ADDENDUM NO. 2:

Date: February 9, 2026
Project: Verbena Elementary School Classroom, Kitchen and Gym Additions
DCM# 2025552

Owner: Chilton County Board of Education
Architect: Ward Scott Morris Architecture, Inc.

TRAFFIC CONTROL PLAN

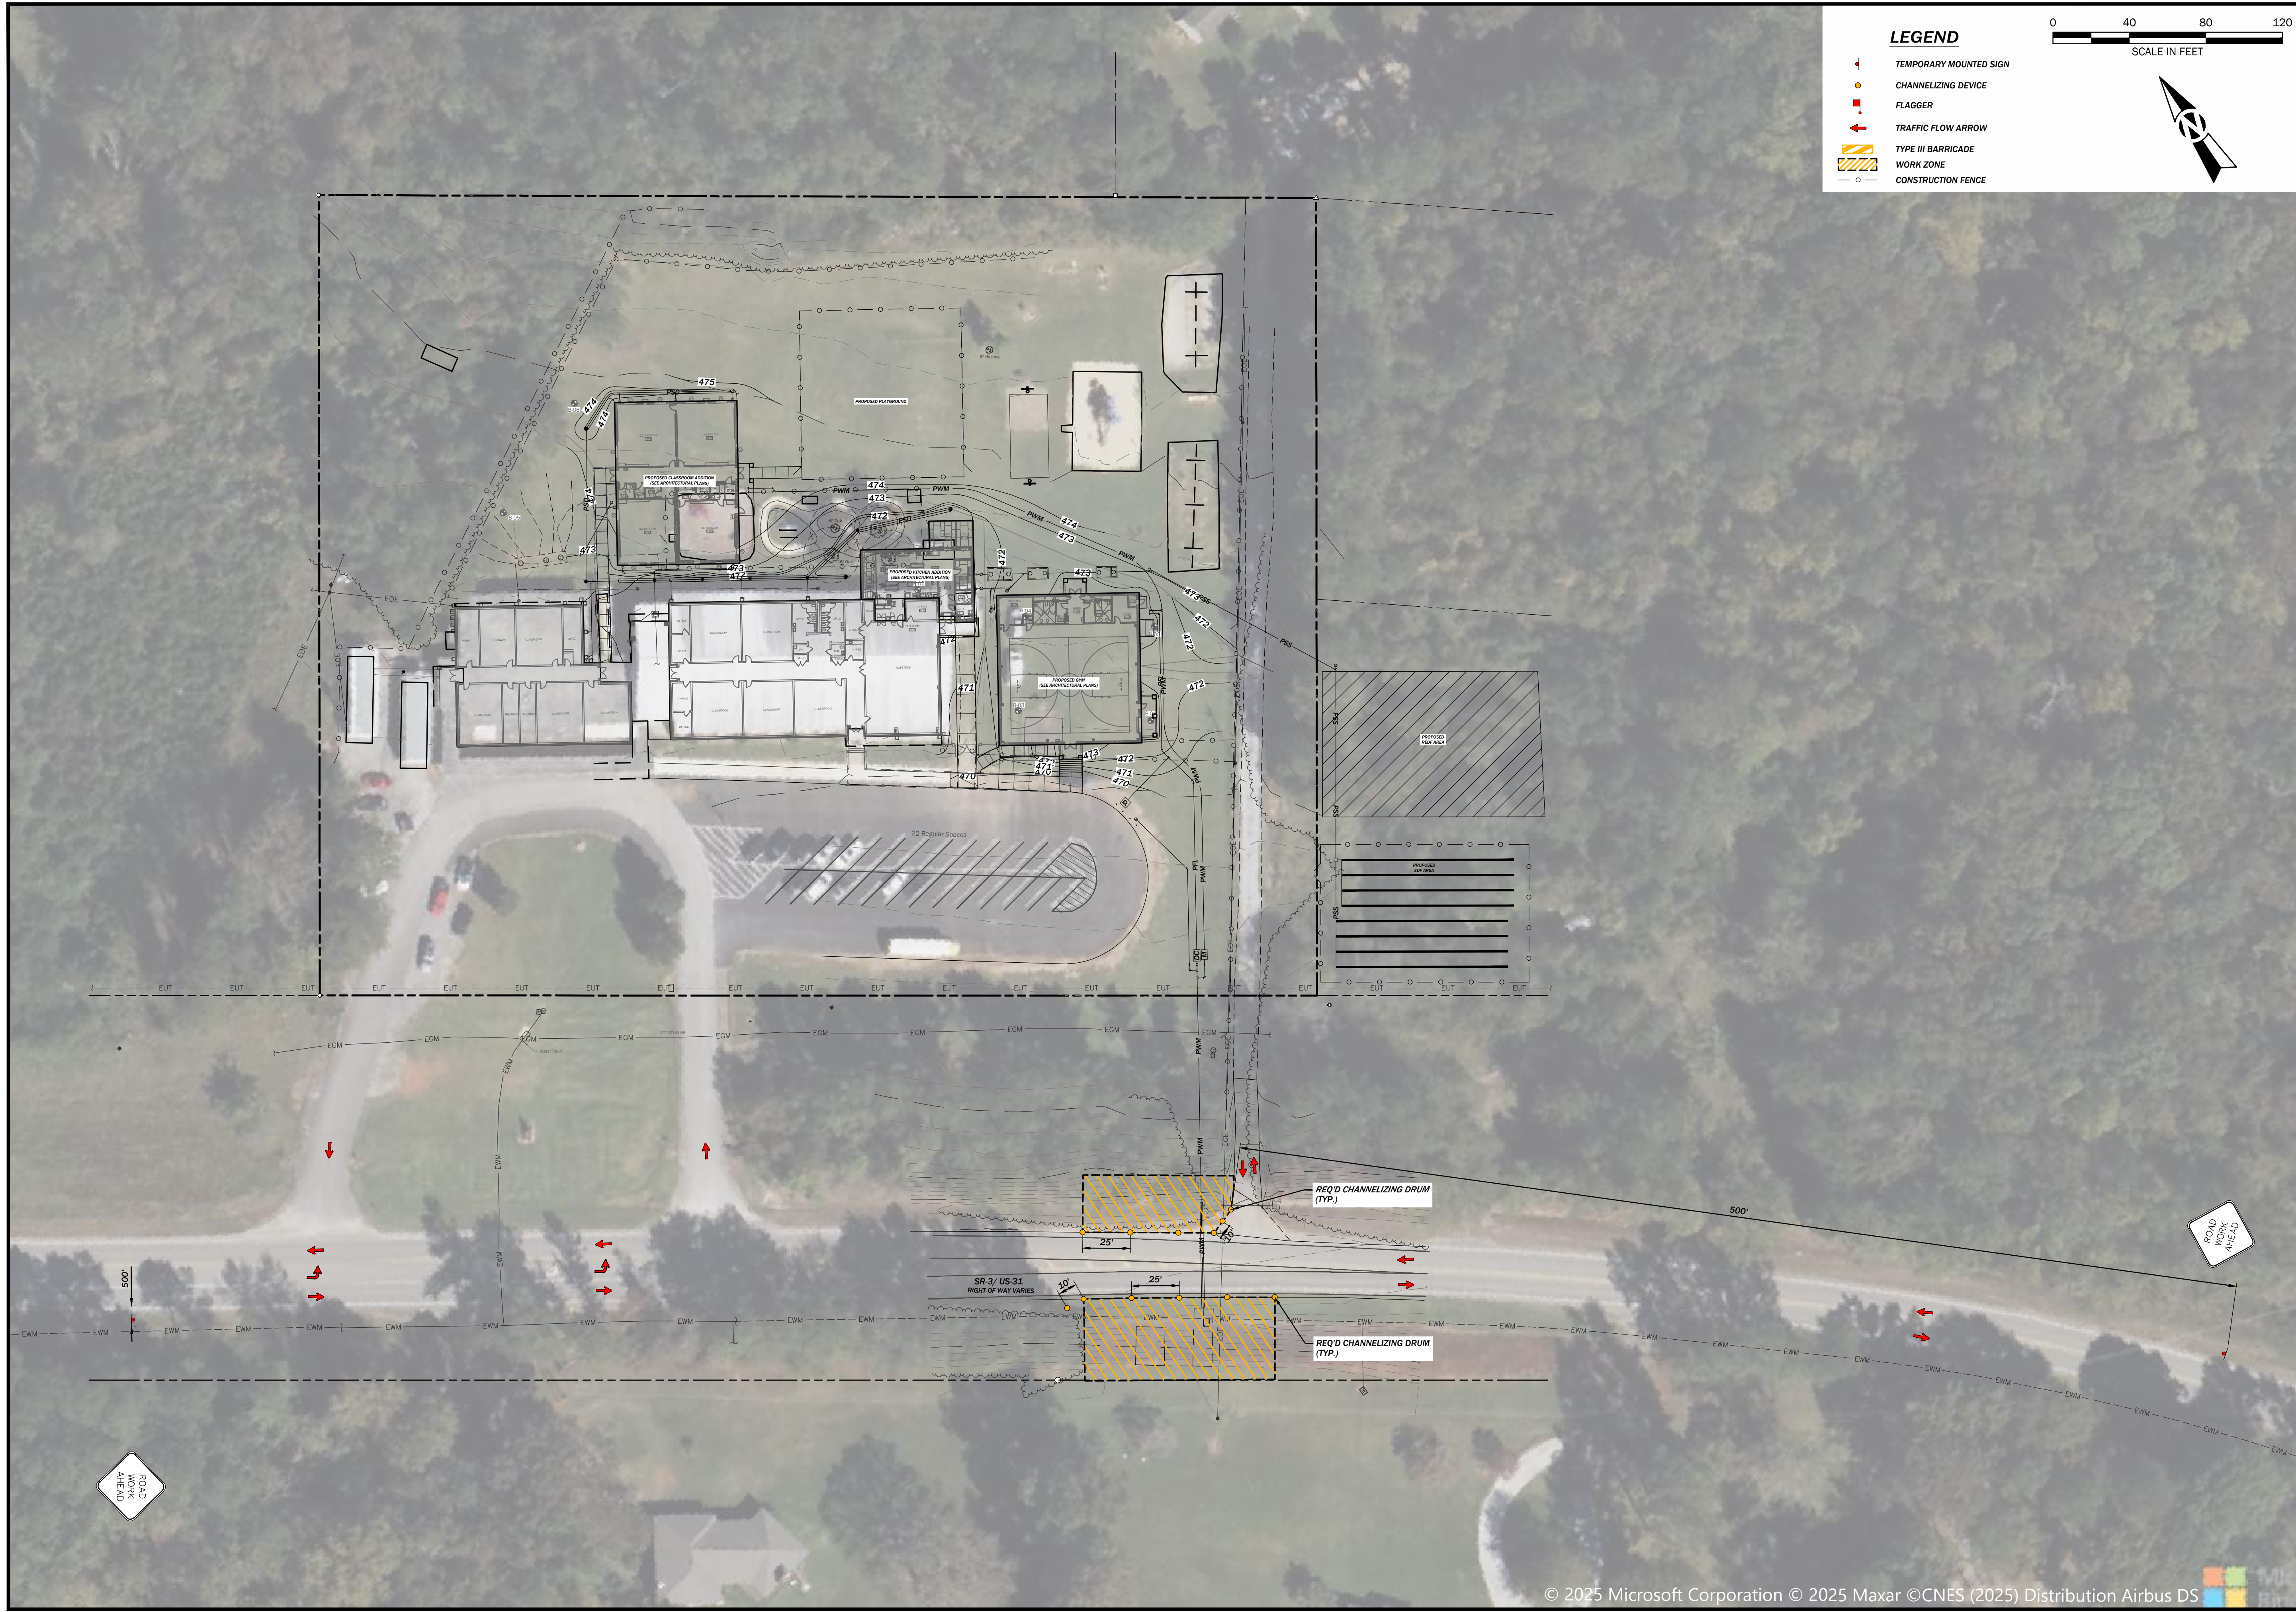
ASI NO. 2 - 03/09/2026
1 - ADDED TRAFFIC CONTROL SHEET C602

3 TYPICAL ENCASUREMENT DETAIL (BORE OR OPEN-CUT)
NOT TO SCALE

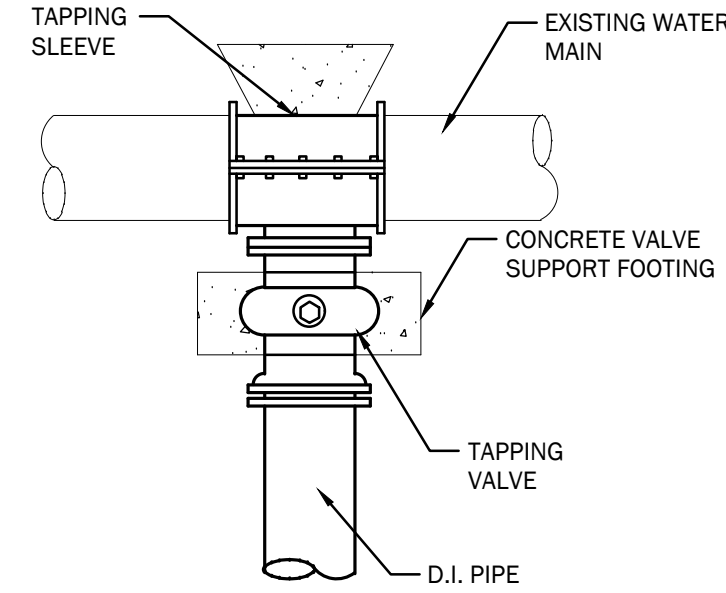
AS1 NO. 2 - 02/09/2026
1. ADDED ENCASUREMENT DETAIL

- NOTES:
- 3 - SPACERS PER JOINT OF PIPE.
 - CARRIER PIPE SPACERS SHALL BE STAINLESS STEEL AS MANUFACTURED BY BMW COMPANY, MODEL BMW-SS OR APPROVED EQUAL.
 - ALL PIPING INSIDE CASING SHALL UTILIZE FAST GRIP RESTRAINED JOINTS OR APPROVED EQUAL.
